Strathfield Local Planning Panel Meeting

Thursday, 7 November 2019

TO: Strathfield Local Planning Panel Meeting - 7 November 2019
REPORT: SLPP – Report No. 1
SUBJECT: DA2019/064 - 8.2 REVIEW - 12 TERRY STREET EAST, STRATHFIELD SOUTH
LOTS 2 & 3 DP 207560
DA NO. DA2019/064 (Section 8.2 Review)

Proposal: S8.2 review application of determination for demolition of existing structures and construction of a pair of semi-detached dwellings and boundary adjustment.

Figure 8: Site plan of proposed development

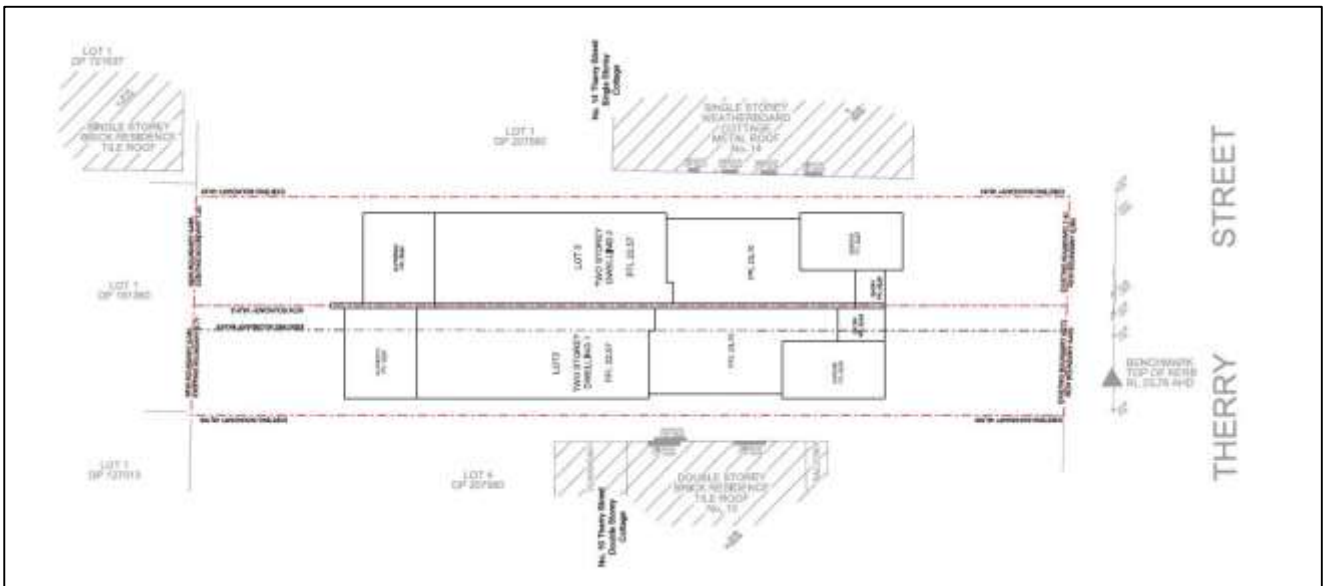
It is apparent that the narrow and elongated design of the proposed semi-detached dwellings is a response to the proposed lots' limited size and width. These restrictive dimensions do not allow for a residential built form that provides appropriate presentation to Therry Street East, public space and from private properties. The proposed semi-detached dwellings feature expansive, dual level walls that stretch along considerable depths of the site (refer to **Figures 8 and 9**). These walls have minimal articulation to interrupt the massing of the side elevations. As a result, these elevations are considered excessive, particularly when viewed from the adjoining properties, and will therefore have unacceptable visual amenity impacts.

Figure 10: North (front) elevation of proposed semi-detached dwellings

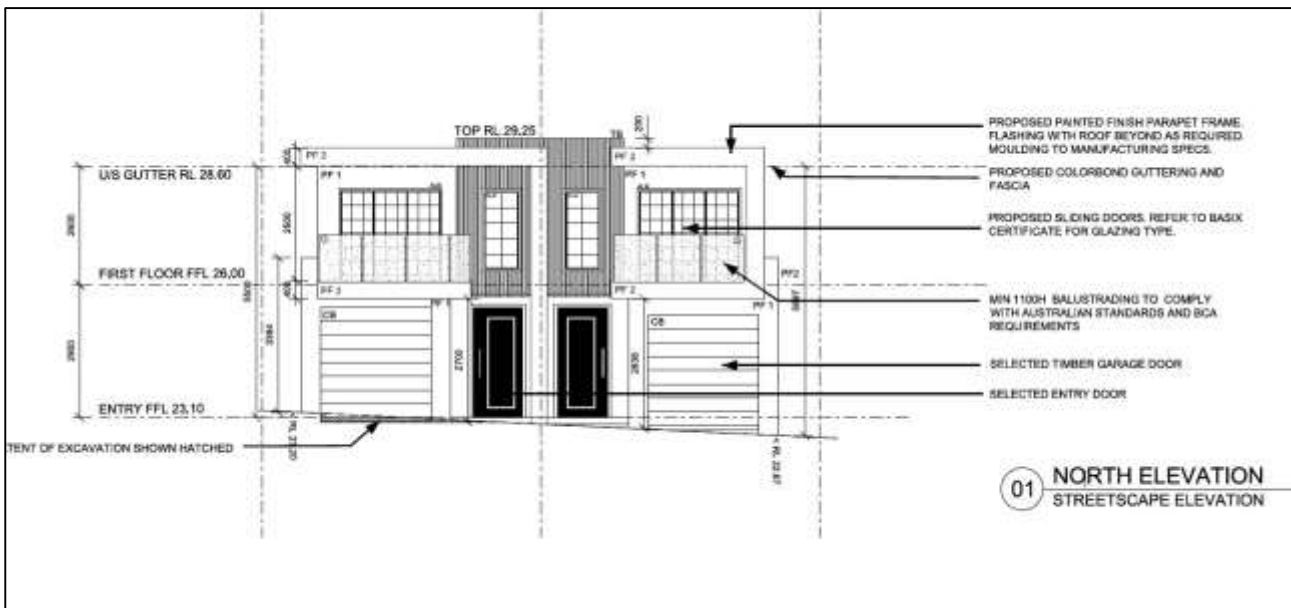
In terms of streetscape presentation, the proposed development will feature a unique residential building that is uncharacteristic of the locality, including along Therry Street East. The provision of two (2) separate driveways, two (2) distinct garages and front entries, and two (2) independent pedestrian paths within the front setback, combined with the narrow widths of each lot, significantly restricts the ability for the site to provide adequate deep soil landscaping treatments to obscure any views of the built form and achieve a more balanced scheme with a high aesthetic quality (refer to **Figure 10**).

Figure 11: Section along the eastern elevation which shows the balustrading and plant screening which breaches the building height development control.

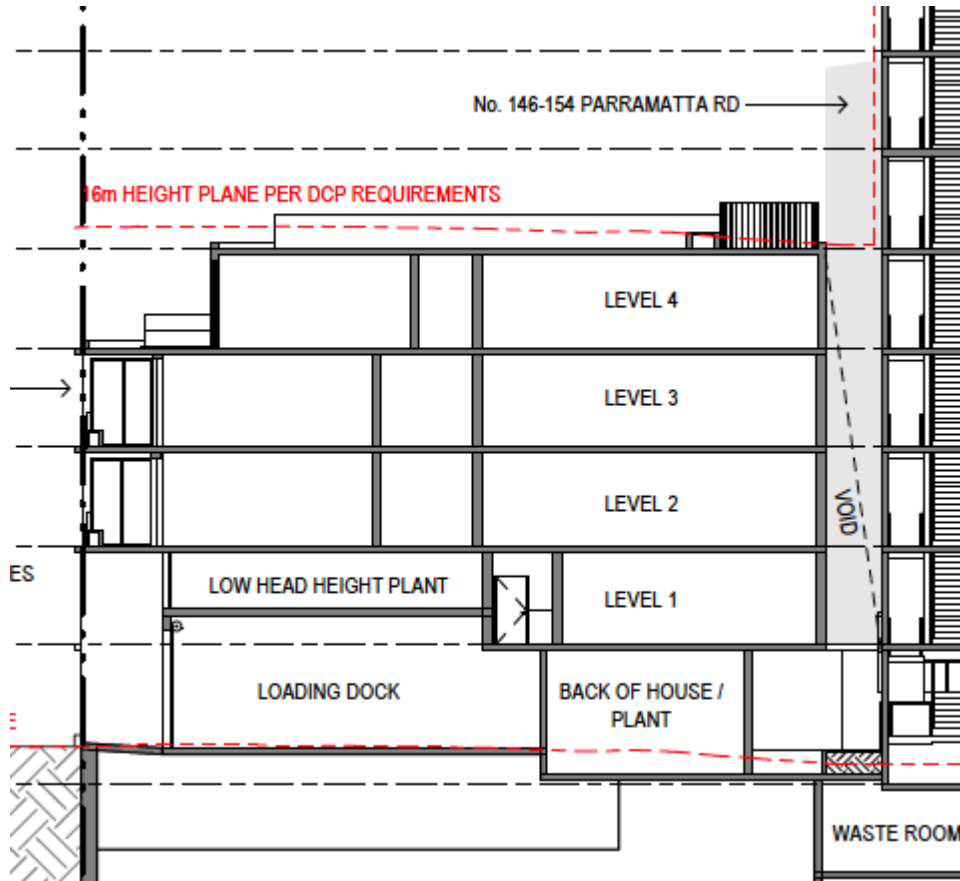
- the top of the clear balustrade around the rooftop communal open space area which breaches the 16m building height limit by approximately 1000mm or 6.25% (Figure 11);
- The planter boxes at the rooftop open space area breach the building height limit by approximately 100mm or 0.6%;
- The screened rooftop plant adjacent to the communal open space area which breaches the building height limit of 16m by approximately 800mm or 5% (Figure 11); and
- The lift overrun which breaches the building height limit of 32m by approximately 200mm or 0.6% (Figure 12).

Figure 6: Proposed 13 spaces located in basement level 1 directly beneath Building 3.

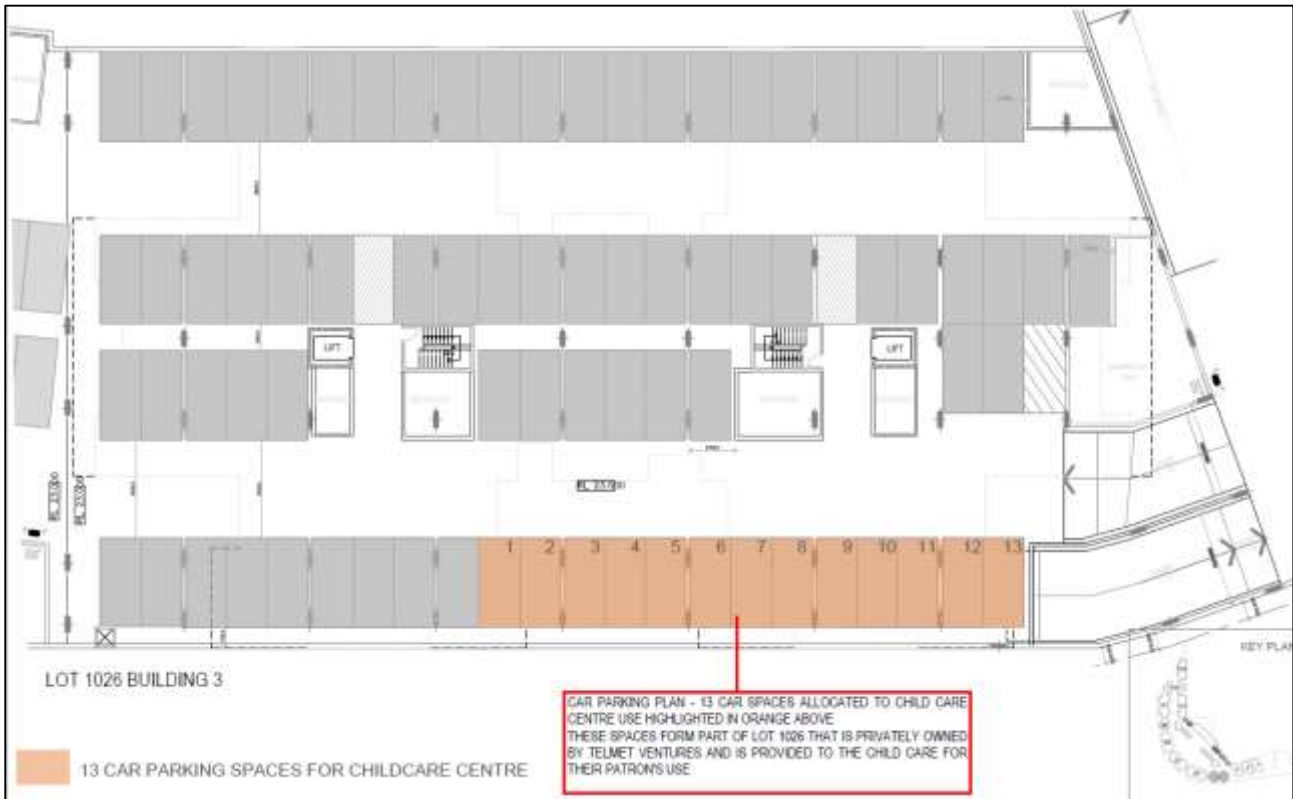
With regard to off-street parking demands, an additional (13) parking spaces are proposed to be have been allocated to the child care. The spaces are located in the shared basement (directly beneath Building 3) to accommodate for the anticipated additional parking demands. The basement is shared between Buildings 2,3 and 4. The childcare centre is located within Building 4 with Buildings 2 and 3 containing residential units only (refer to Figure 5). Concern is raised that the allocation of new parking spaces directly beneath the adjoining building (Building 3) is not appropriately located and that the location of the spaces would require patrons to negotiate incoming/outgoing residential traffic to access the facility. The existing and proposed car parking provisions of the site are therefore inadequate to cater for the likely and anticipated additional demand without adversely affecting surround road networks.

Figure 7: Proposed acoustic barrier with awning extension as recommended in the revised Acoustic Report.

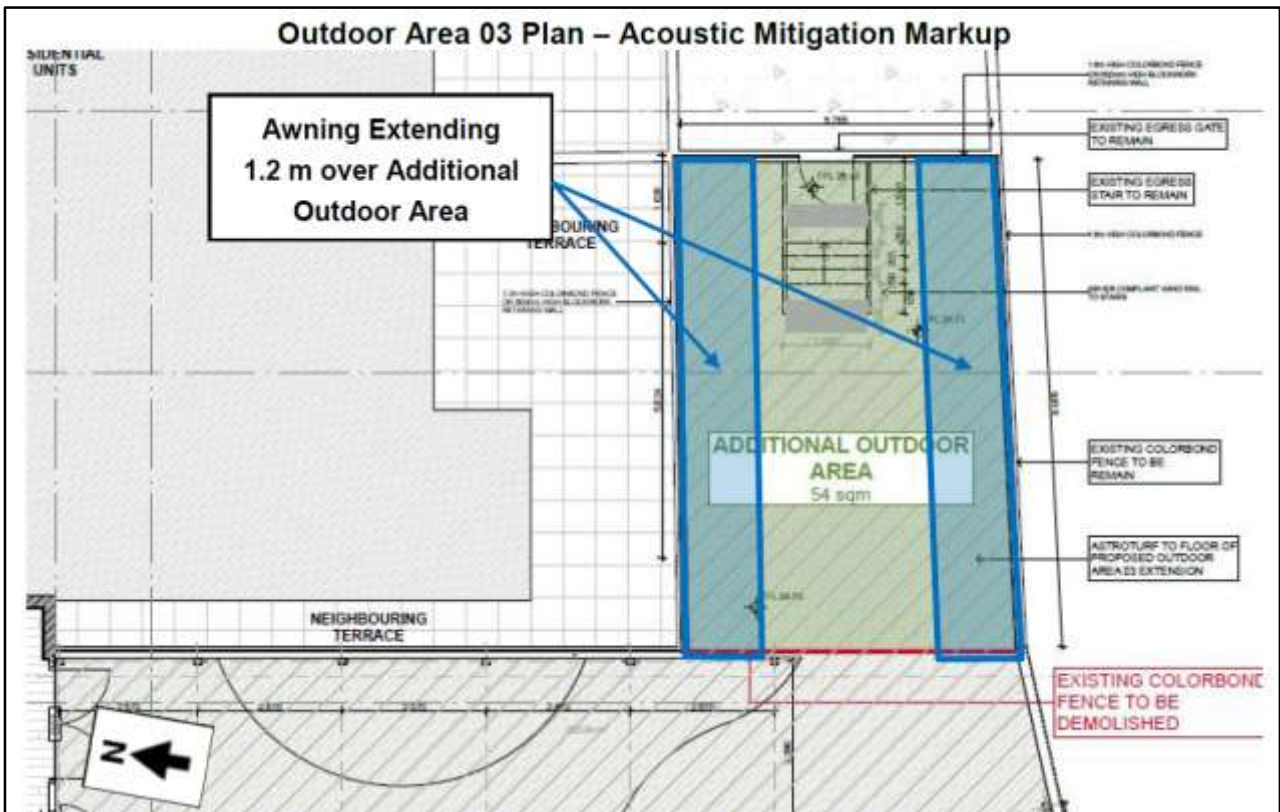
Comments: The revised Acoustic Report has identified that children playing in the outdoor play areas 01, 02 and 03 exceed the project noise trigger level for the site as determined in the NSW EPA Noise Policy for Industry 2017. To minimise noise levels in outdoor play area 03 (Figure 7), the submitted Acoustic Report recommends additional barriers/screens with an awning to be constructed within Lot 881 (the centre) extending for a distance of 1.2m over the additional outdoor area. The barriers are recommended to extend along the northern and southern parameters of the additional outdoor area. These are depicted in the following figures 7,8 and 9 as provided in the revised report.
